Sea Link Grid Reinforcement

Targeted Consultation on Changes to Sea Link Proposals

Suffolk County Council Response

August 2024

Site specific comments:

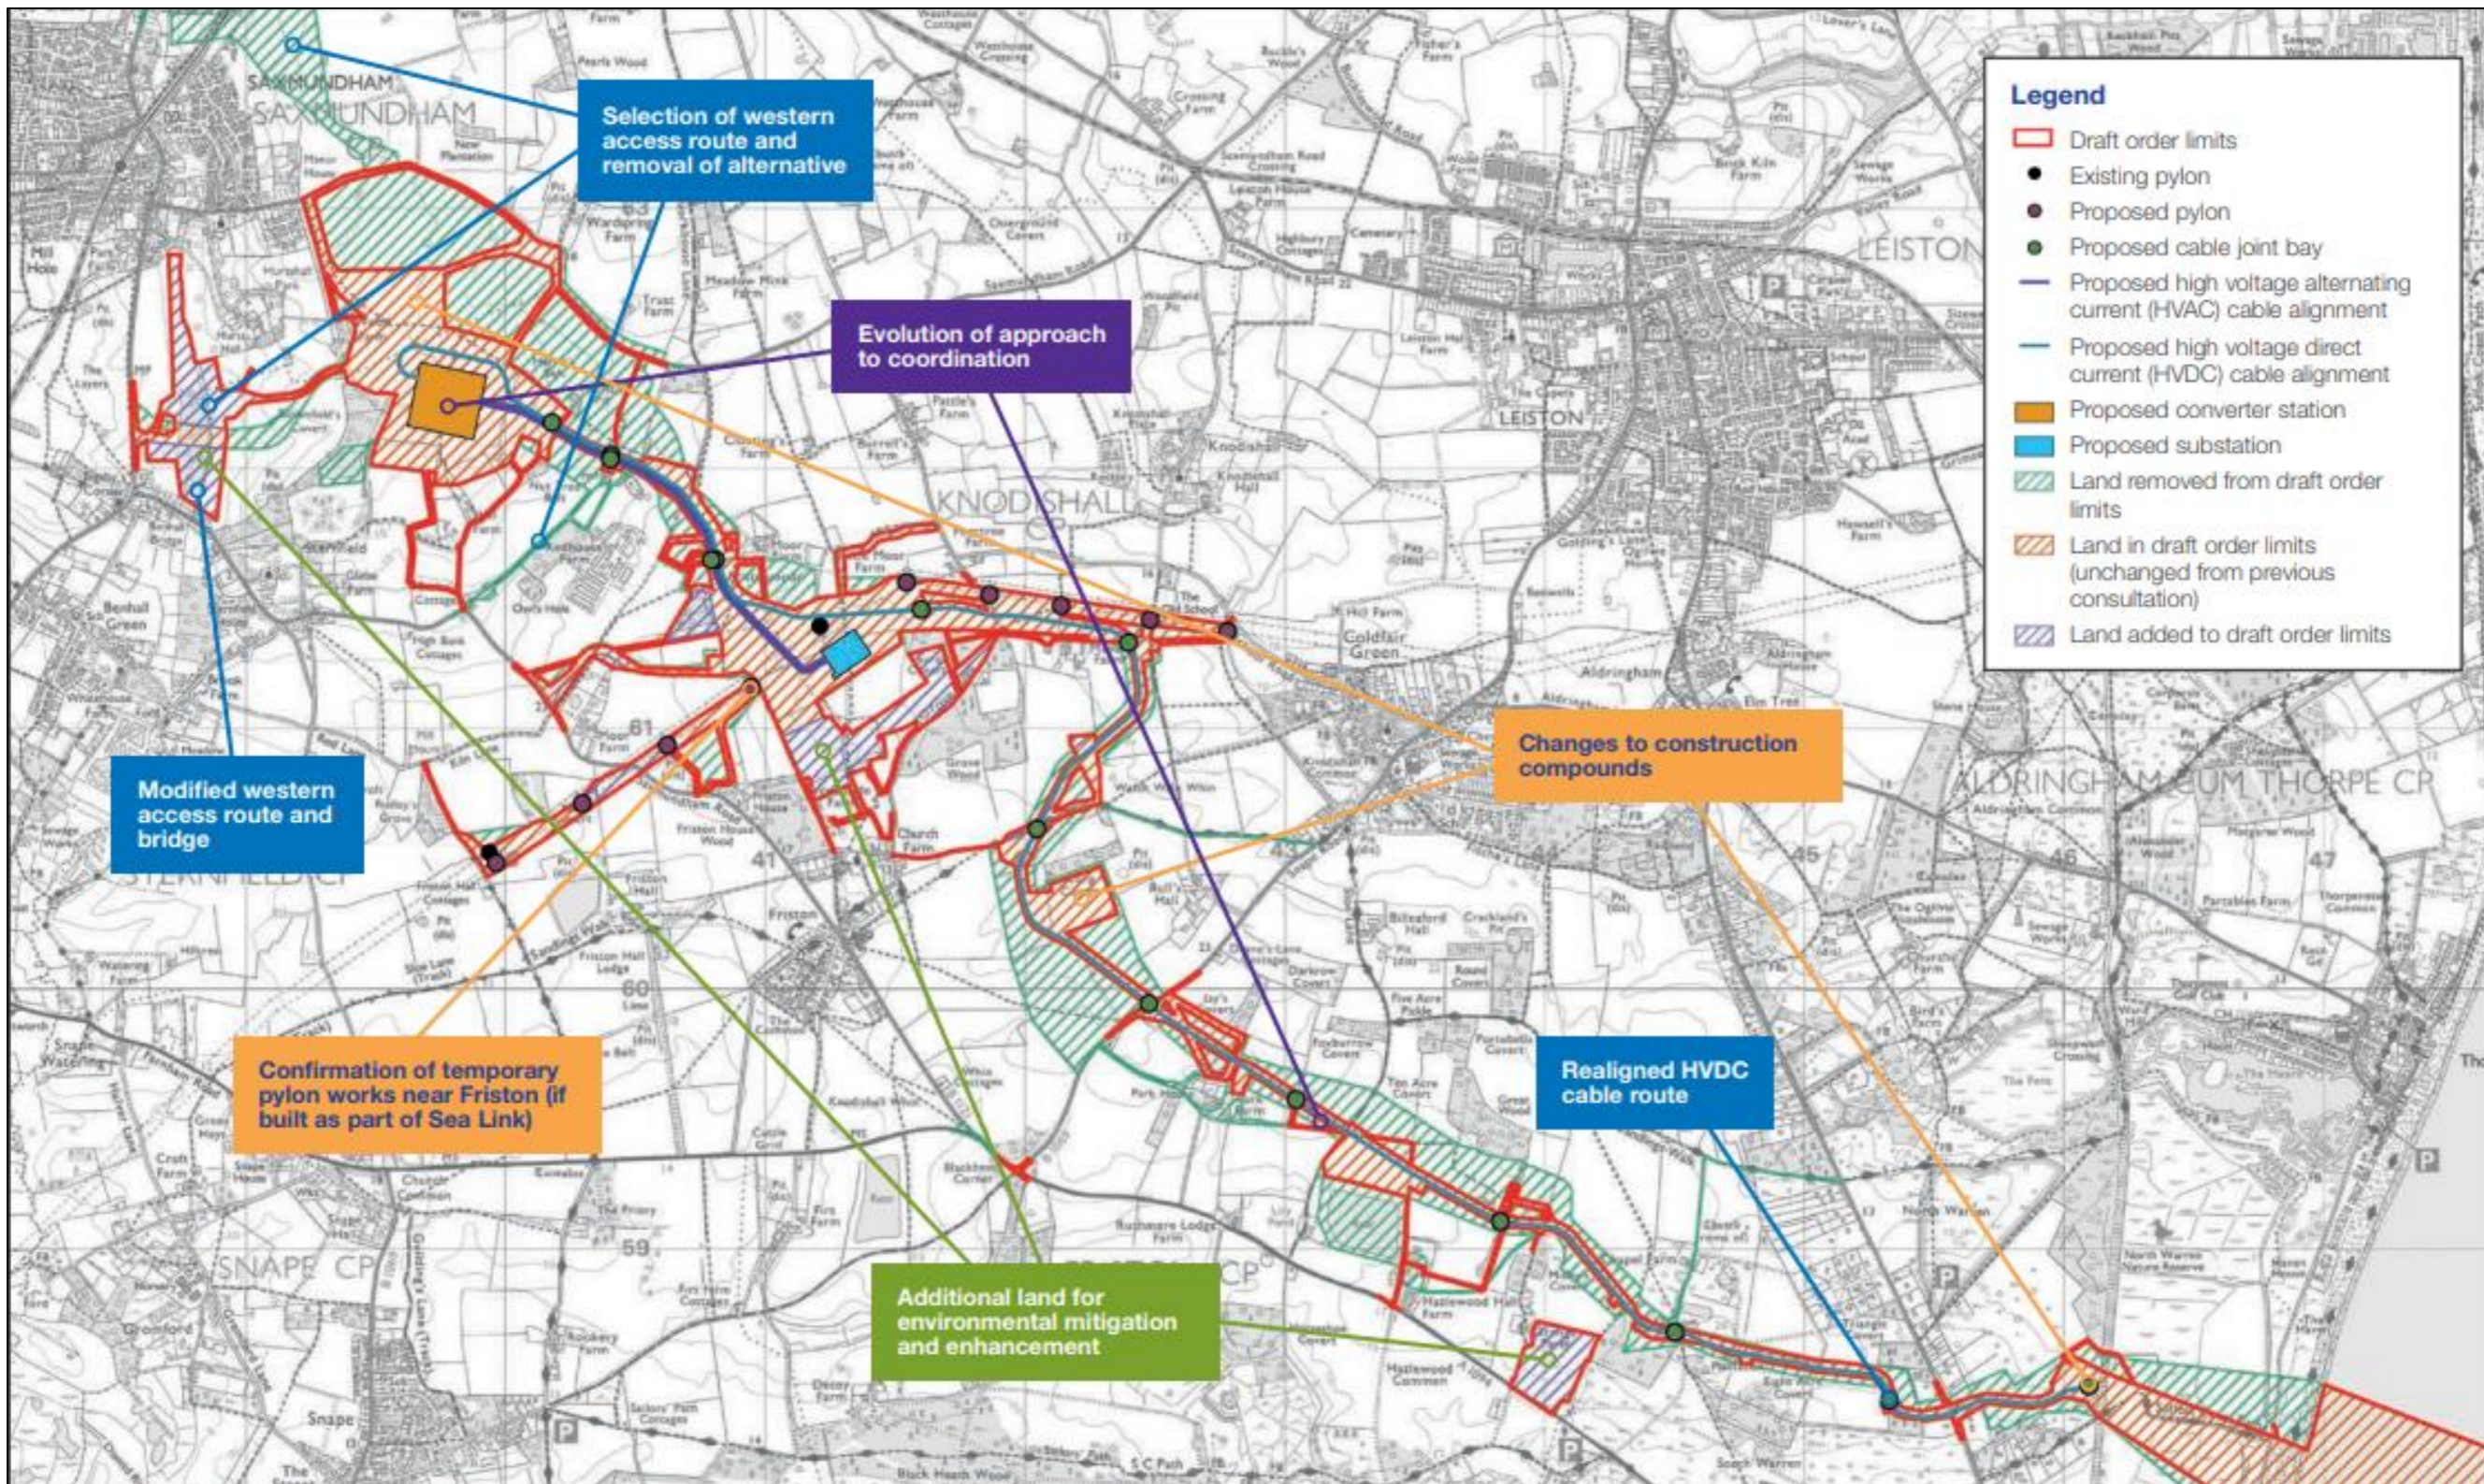
- 14.18 The order limits appear to show access gained off School Road. Whilst noting that there is a field entrance here the access may not be appropriate for use by construction traffic and that and changes will impact the footpath that is located here (E-354/018/0 Knodishall Public Footpath 018).
- 14.19 Where the County Council considers suitable mitigation for the impact of the NSIP on PRow and other green access is not appropriate, it will seek financial compensation. Please see the County Council guidance "Public Rights of Way and Green Access Supplementary Guidance Document".
